WATER QUALITY MEMORANDUM

Utah Coal Regulatory Program

RE: First Quarter of 2014 (Q4) Water Monitoring, PacifiCorp, Deer Creek Mine. C/015/0018, Task ID #4540

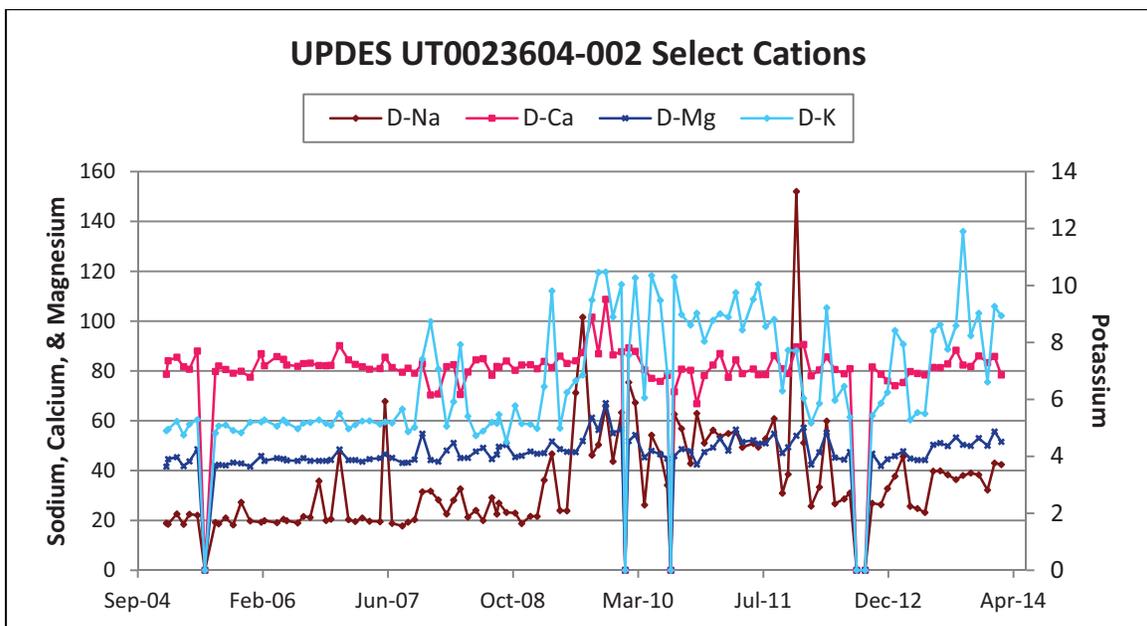
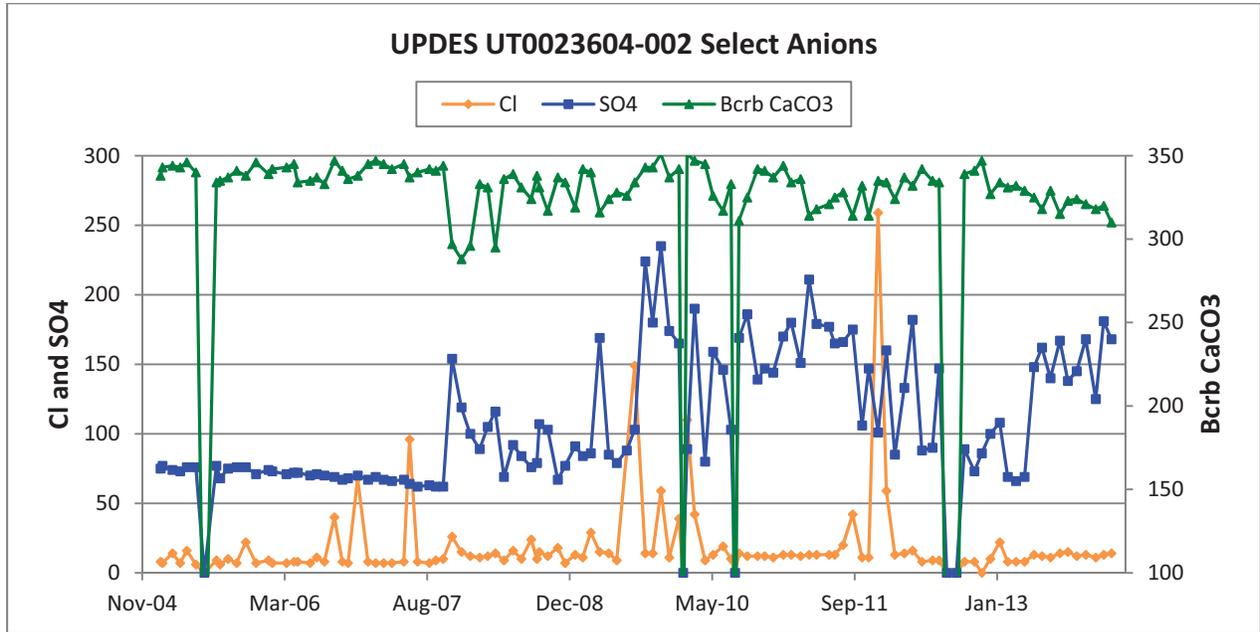
Recently, potassium values have frequently been outside two standard deviations from

the mean at UT0023604-002. The following charts show Cl, D-Na, D-Ca, D-Mg ion concentrations have been trending upwards in recent years, while bicarbonate and D-K have been downward trending.

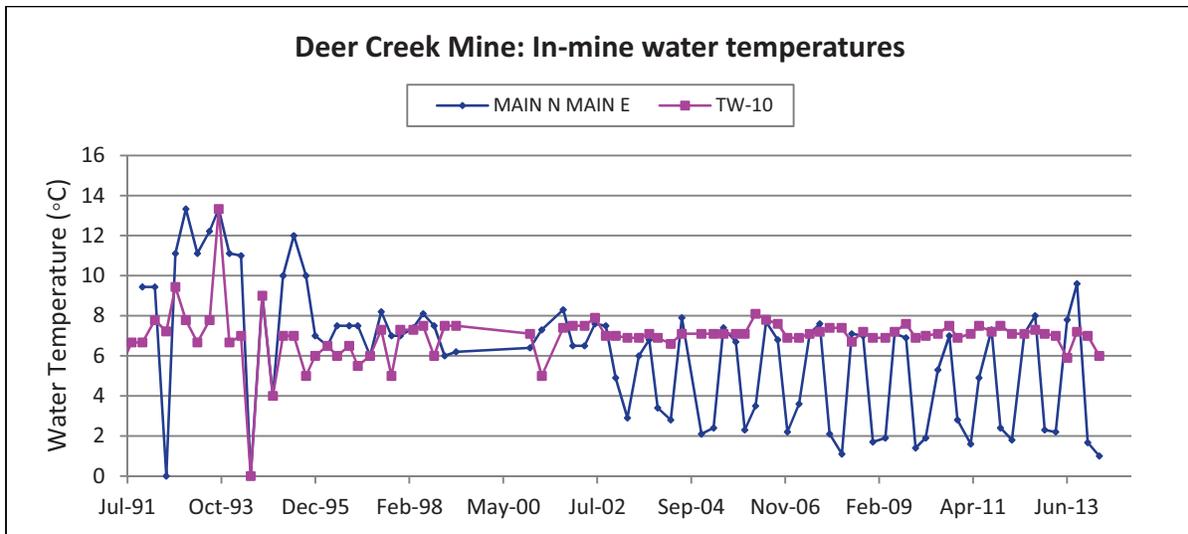
The cation-anion value was more than two standard deviations from the mean at Main N Main E and TW-10 in March. The water temperature at Main North Main East varies seasonally year-after-year (see following chart), indicating that this in-mine source is most likely fed by infiltrating surface water rather than draining surrounding strata. The temperature at TW-10 shows some seasonal variation, but it is not as definitive as at Main North Main East.

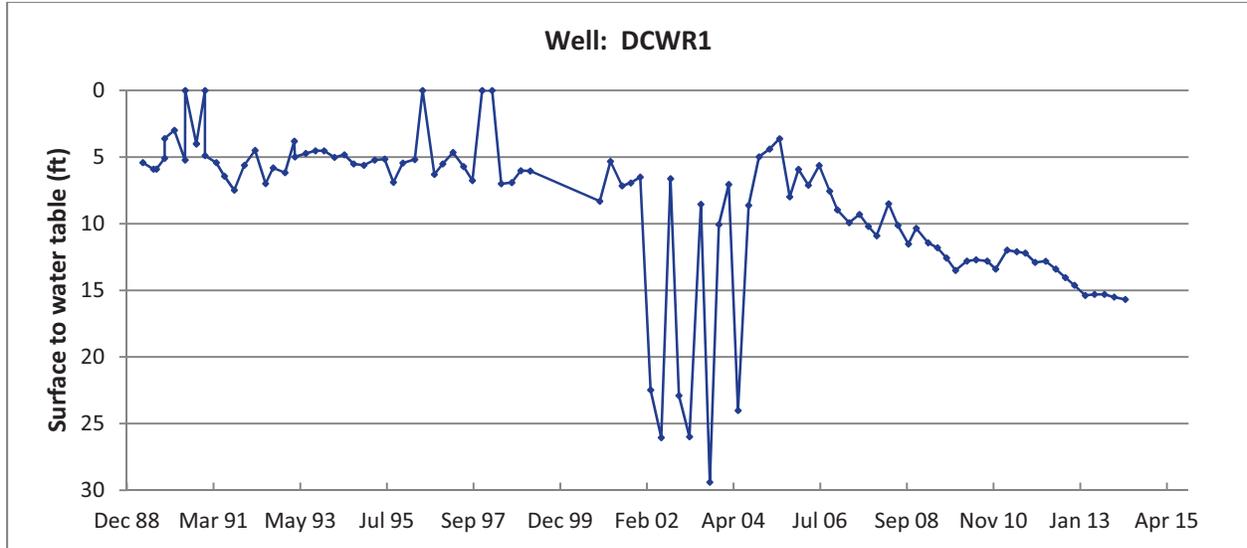
Although it hasn't been flagged as varying from the mean by more than two standard deviations, water level at DCWR1 has been dropping since 2006 (following a small rise in 2004-2005). TDS was dropping at a similar rate, but now appears to have stabilized. These changes are probably from factors other than disposal of waste rock at this site: a similar drop in water level is seen at WCWR1 at the Cottonwood/Wilberg Mine Waste Rock Disposal Site.
